STAFF REPORT
COMMUNITY DEVELOPMENT DEPARTMENT

SUBJECT: FP-2020-0005
Edington Commons No. 1

I. PROJECT DESCRIPTION

Final plat consisting of 45 buildable lots and 9 common lots on 7.73 acres of land in the R-15 zoning district.

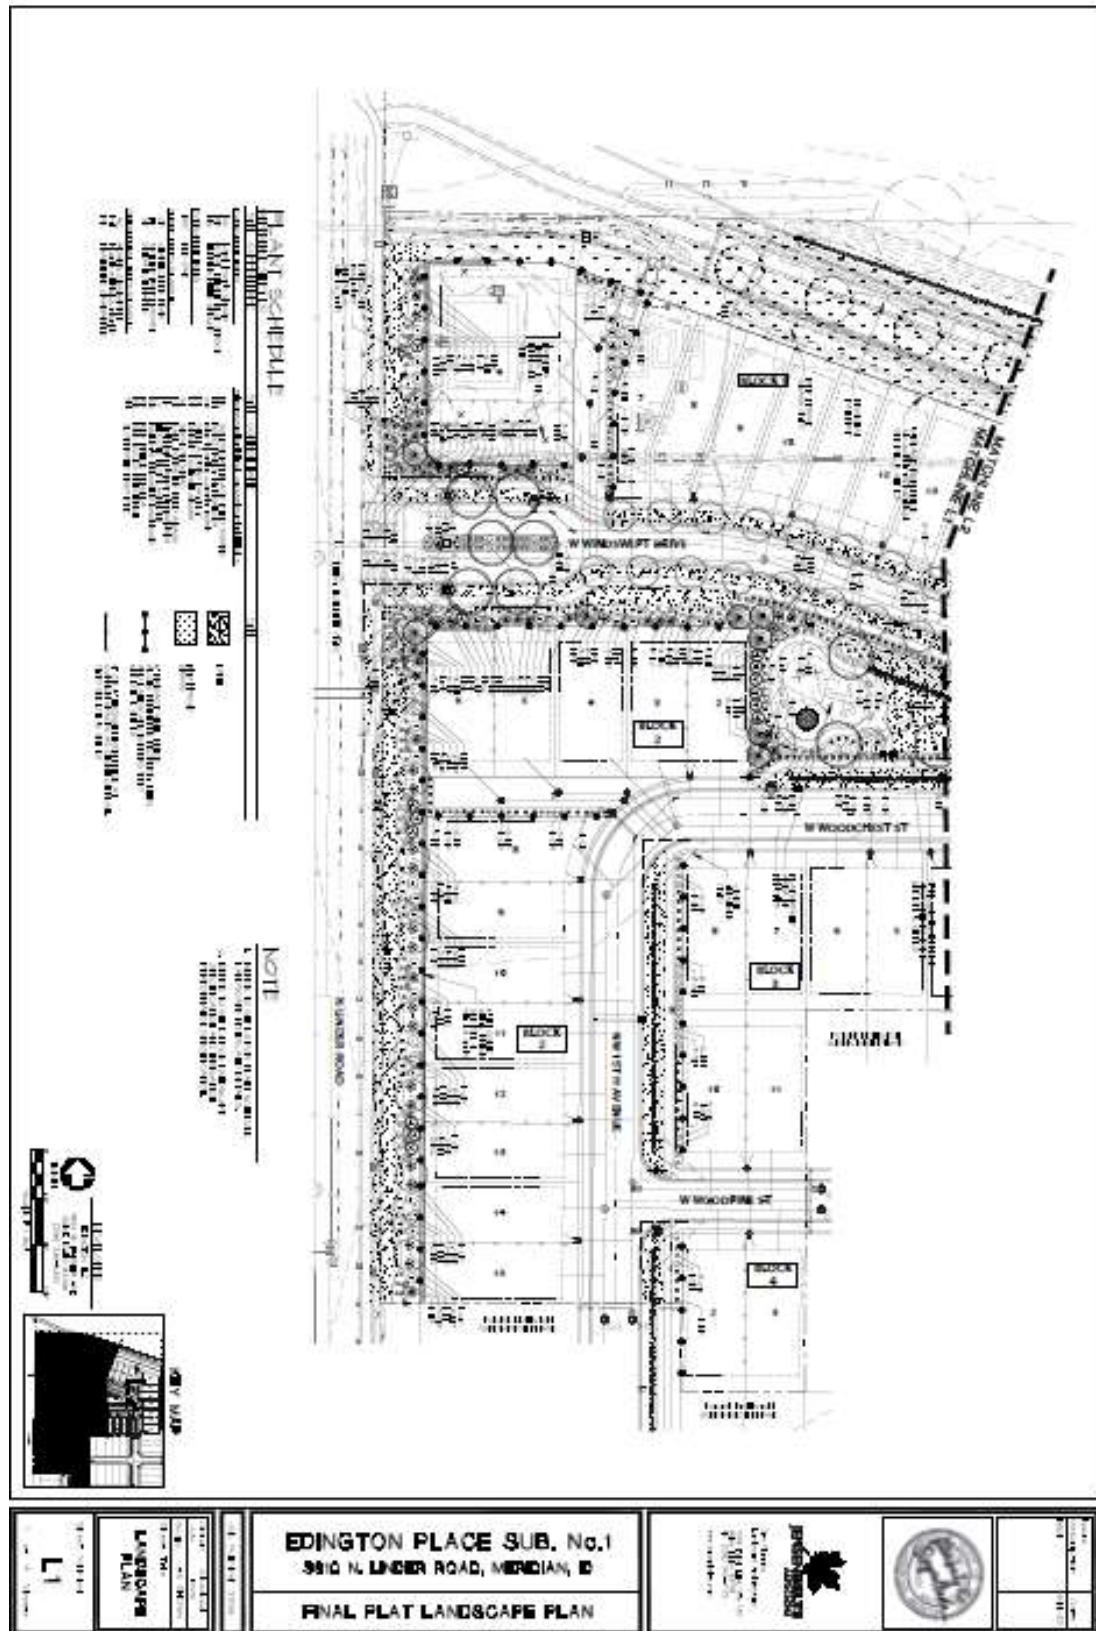
3. Prior to submittal for the City Engineer's signature, have the Certificate of Owners and the accompanying acknowledgement signed and notarized.
4. The final plat prepared by Sawtooth Land Surveying, stamped by Kevin M. Borah, dated: 10/27/2020, included in Section V.B shall be revised as follows:

- a. Note #7: Include the recorded instrument number of the ACHD license agreement.
 - b. Note #8: Include the recorded instrument number for irrigation water from Meridian Project.

- c. Note #10: Include the correct recorded instrument for the Development Agreement (#2020-044056).
 - d. Note #14: Include the recorded date and instrument number of the ACHD storm water drainage easement and graphically depict the locations of the easement on the plat.

- e. Note #15: Include the recorded instrument number of the ACHD sidewalk easement.
 - f. Legend: Include the recorded instrument number of the Coleman Lateral easement.

- g. Legend: Include the recorded instrument number of the ACHD slope easement.
 - h. A minimum 15-foot wide common lot shall be provided between Lots 17 and 18, Block 1 for a micropath in accord with preliminary plat condition #2b; *or*, the area may be included in Lot 18, Block 1. *Note: A minimum 5-foot wide landscape strip is required on each side of the pathway in accord with the standards listed in UDC 11-3B-12C.*

- i. Surveyor's Narrative: Delete portions of note pertaining to a gap from the monuments between the Fuller Ranchette's and Dunwoody Subdivision as it's not applicable.

A copy of the revised plat shall be submitted for City Engineer signature.

C. Landscape Plan (dated: 8/14/2020) & Site Amenities

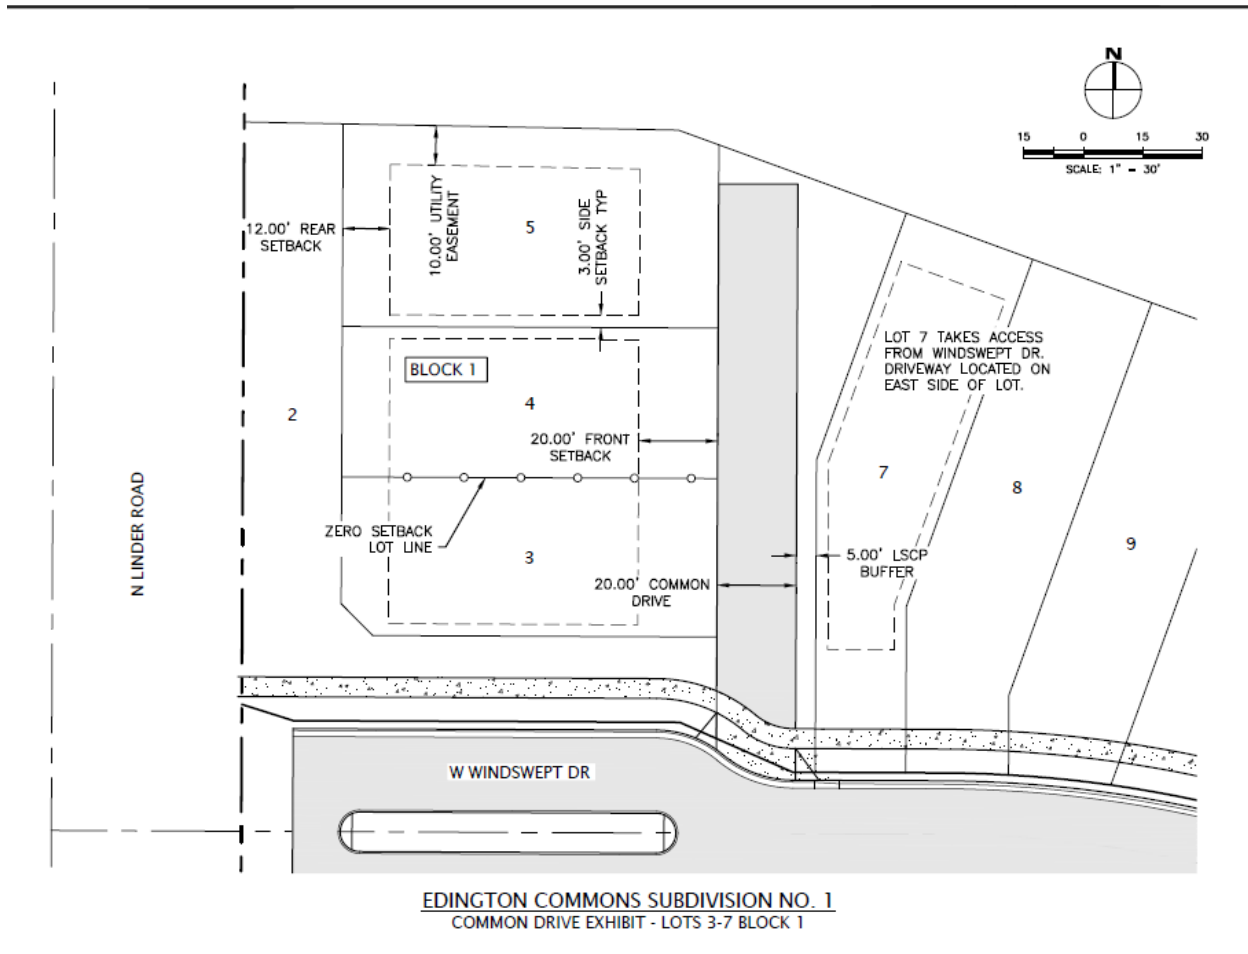
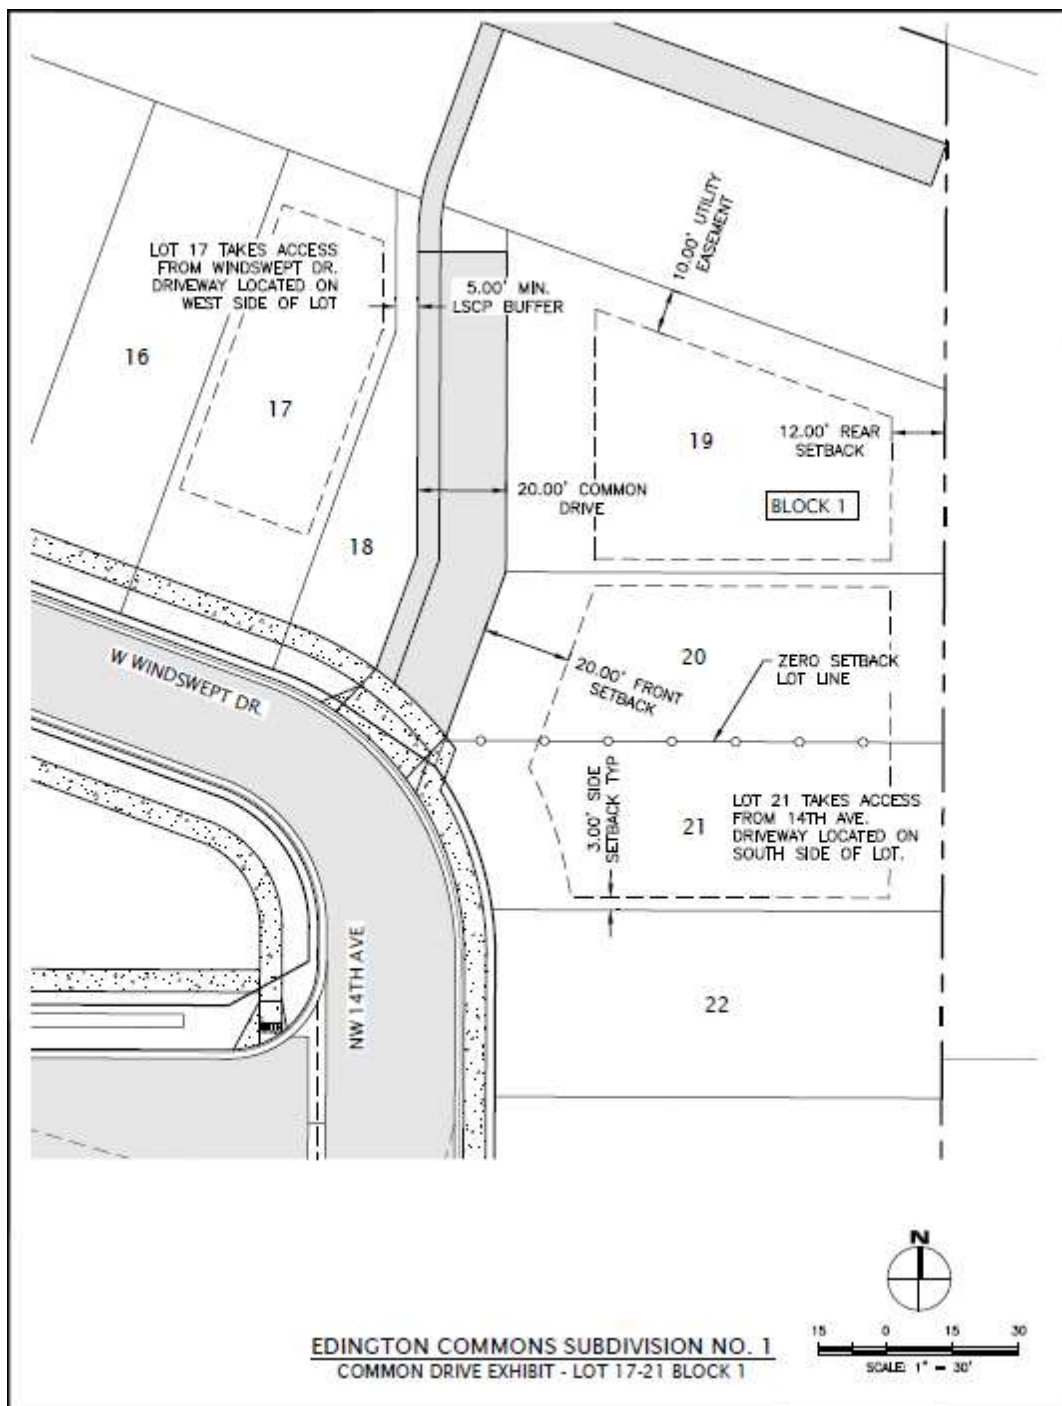
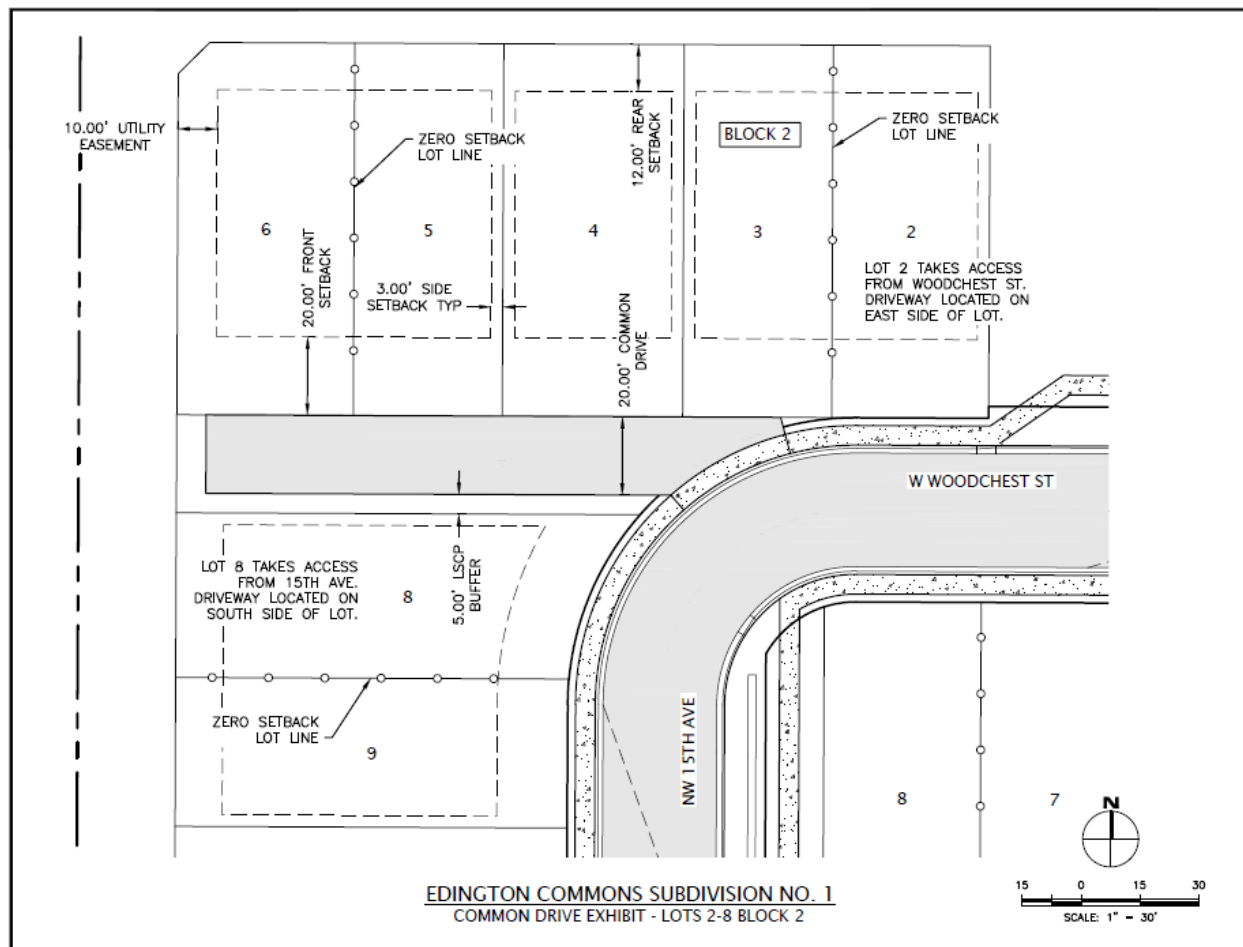
5. The landscape plan prepared by Jensen Belts Assoc., dated 08/14/2020, included in Section V.C, shall be revised as follows:
 - a. A minimum 15-foot wide common lot shall be provided between Lots 17 and 18, Block 1 for a micropath and landscaping in accord with preliminary plat condition #2b; *or*, the area may be included in Lot 18, Block 1. A minimum 5-foot wide landscape strip is required on each side of the pathway landscaped per the standards listed in UDC 11-3B-12C which requires a *mix* of trees, shrubs and/or other vegetative groundcover.

- b. Depict the 40-foot wide irrigation easement for the Coleman Lateral consistent with the plat; the 10-foot wide multi-use pathway with 5-foot wide landscape strips on each side of the pathway shall be located *outside* of the Irrigation District's easement. Depict landscaping along the pathway in accord with the standards listed in UDC 11-3B-12C, which requires a *mix* of trees, shrubs and/or other vegetative groundcover.

- c. Include the linear feet of parkways and required & provided trees in the calculations table on Sheet L3 of the landscape plan that demonstrate compliance with the standards listed in UDC 11-3B-7C.

- d. Include the linear feet of pathways and required & provided number of trees in the calculations table on Sheet L3 that demonstrate compliance with the standards listed in UDC 11-3B-12C.

- e. Depict mitigation trees and calculations on the plan in accord with the standards listed in UDC 11-3B-10C.5. *Coordinate with Matt Perkins, the City Arborist, to determine mitigation requirements prior to removal of any trees from the site.*

- f. If the unimproved right-of-way of N. Linder Rd. is 10 feet or greater from the edge of pavement to edge of sidewalk or property line, the Developer is required to maintain a 10 foot compacted shoulder meeting the construction standards of ACHD and landscape the remainder with lawn or other vegetative ground cover as set forth in UDC 11-3B-7C.5. A license agreement for improvements within the right-of-way is required between the property owner and ACHD.

- g. The Coleman Lateral shall be piped as proposed by the Applicant with the preliminary plat; remove the depiction of the open waterway from the plan per preliminary plat condition #3e.

D. Common Driveway Exhibits

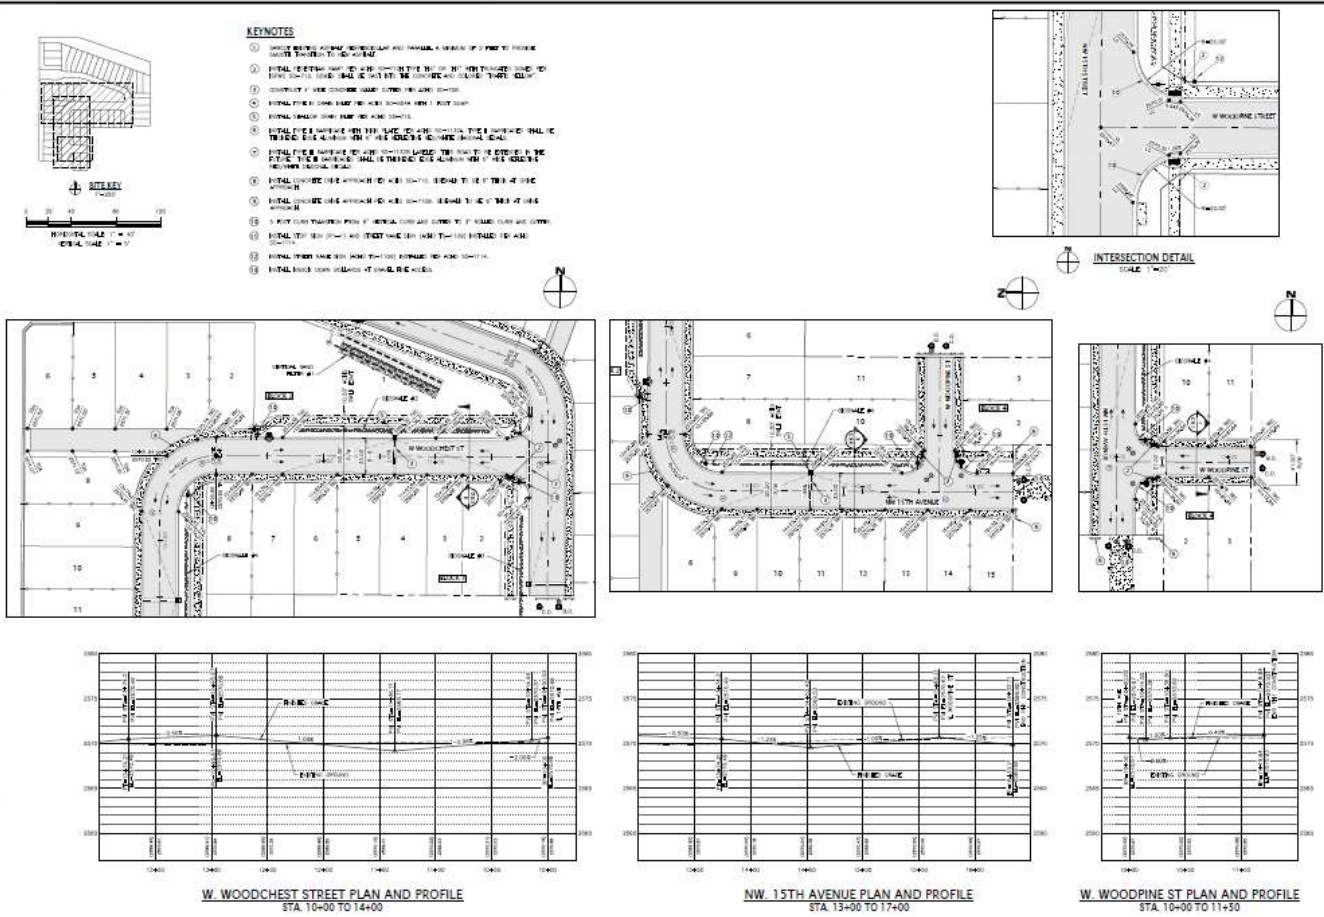
6. Construction of the common driveways on Lots 6 and 18, Block 1 and Lot 7, Block 2 shall comply with the standards listed in UDC 11-6C-3D. The lots accessed via the common driveways shall have setbacks consistent with that shown on the exhibits in Section V.D.
